City of Santa Fe, New Mexico

memo

Case # 2016-04. Estancias de Las Soleras Unit 1C Final Subdivision Plat. James W. Siebert & Associates, agent for the Pulte Group requests approval of a Final Subdivision Plat for 67 lots located on 25.86 acres on Tract 11A in the Los Soleras Master Plan which is zoned R-6 (Residential – 6 units per acre). The plat is the final unit of Phase 1 of the overall Pulte residential development. (Donna Wynant, Case Manager)

PROJECT: LAS SOLERAS
 SHEET: TRAILS PLAN
 TOTAL SHEETS: P-12

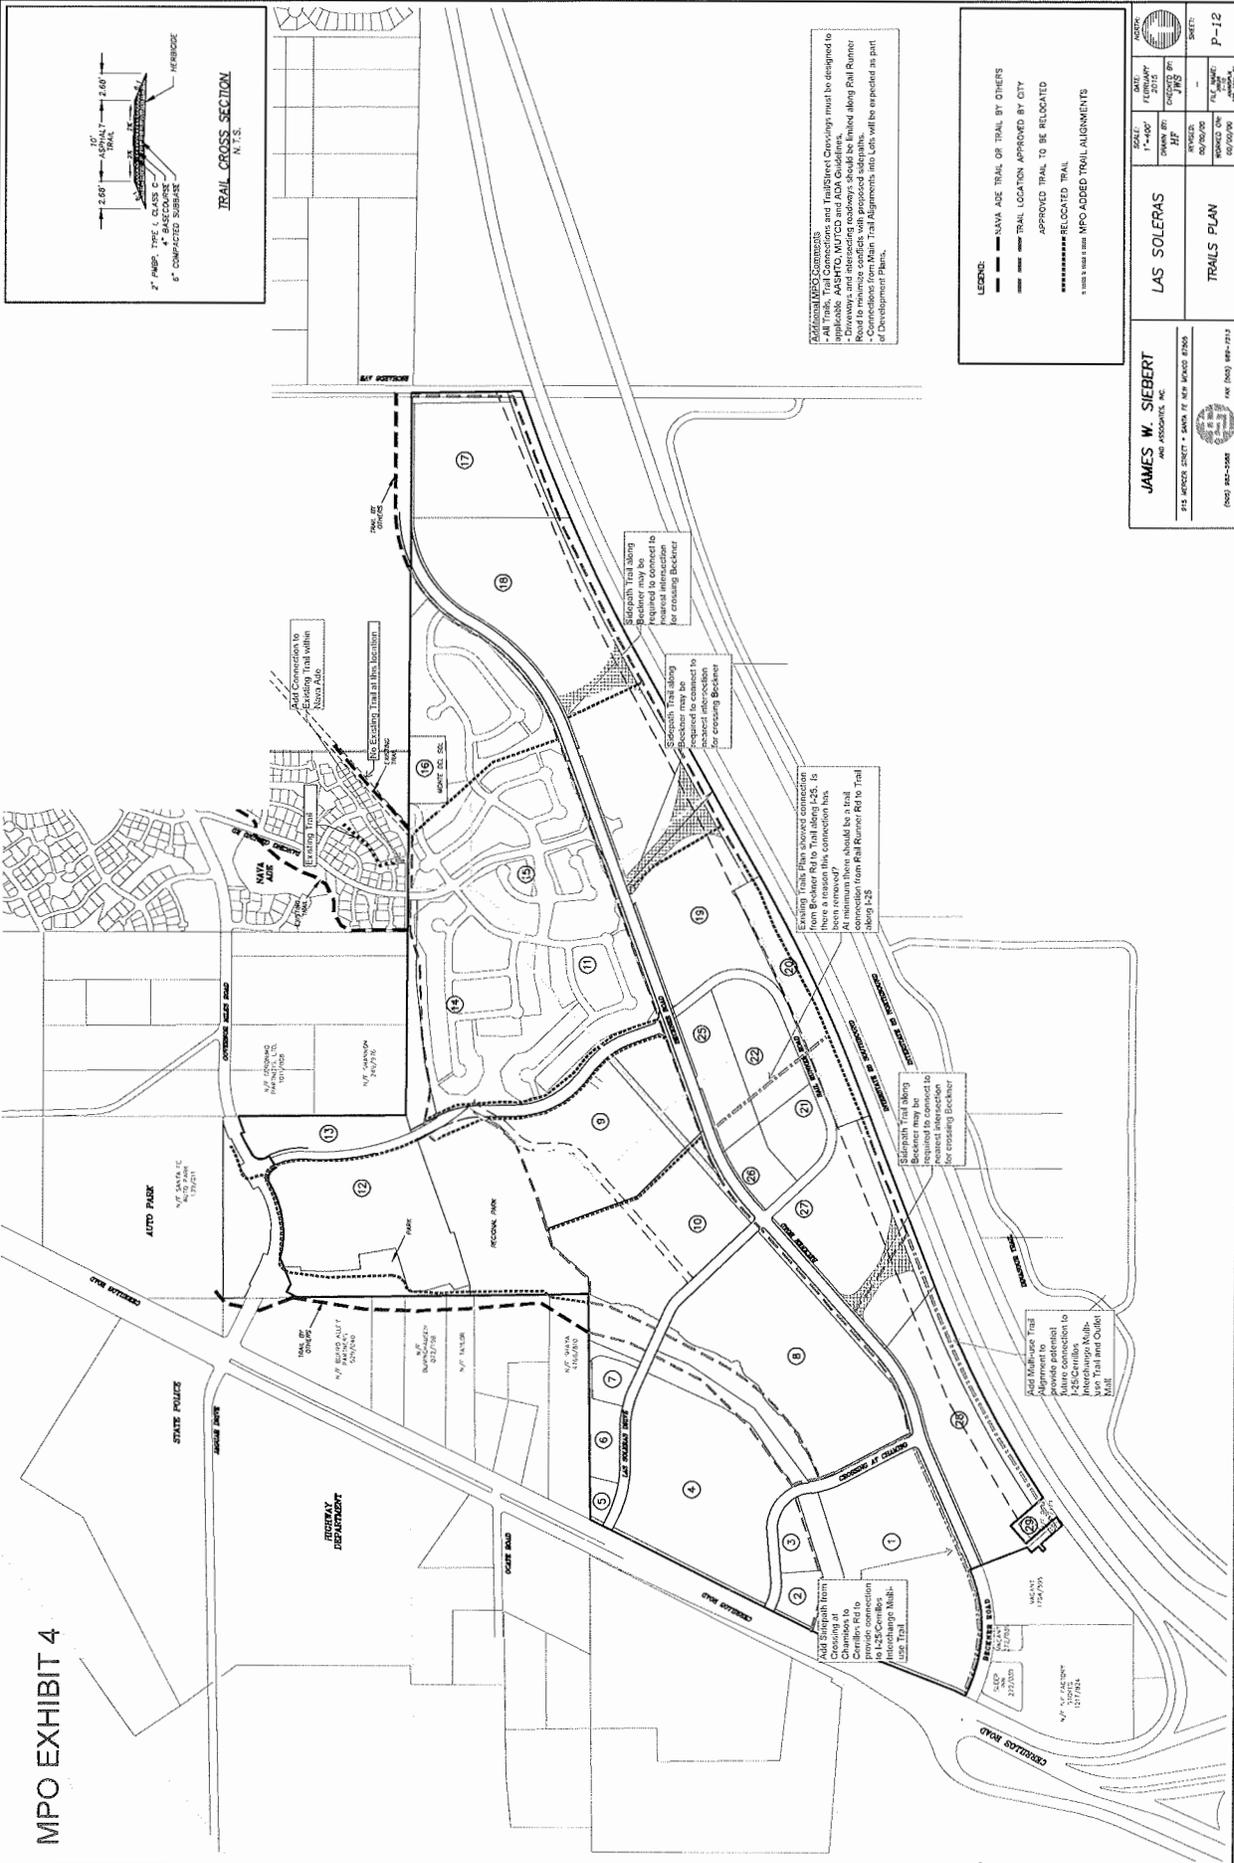
The following conditions are proposed:

- Add a Multi-use Trail ("Sidepath") on the north side of Beckner Road between the Crossing at Chamiso to Cerrillos Road to provide a connection to the I-25/Cerrillos Rd Interchange Multi-use Trail currently under construction.

- Add a Multi-use Trail parallel to I-25 along the southern side of Lots 27, 28 and 29 to provide a potential future connection to the I-25/Cerrillos Rd Interchange Multi-use Trail currently under construction.

- Add a Multi-use Trail from the Trail along I-25 through lots 22 and 25 to connect to the realigned Trail between Lots 9 and 10.
- The Multi-use Trails that intersect with the south side of Beckner Road may be required to be extended to the nearest intersection for crossing of Beckner Road.

- Add a Multi-use Trail Connection to the Existing Trail located between Howling Wolf Ln and Soaring Eagle Ln in Nava Ade.
- All Trails, Trail Connections and Trail/Street Crossings must be designed to applicable AASHTO, MUTCD and ADA Guidelines.

- Driveways and intersecting roadways should be limited along Rail Runner Road to minimize conflicts with proposed sidepaths.
- Connections from Main Trail Alignments into Lots will be expected as part of Development Plans.
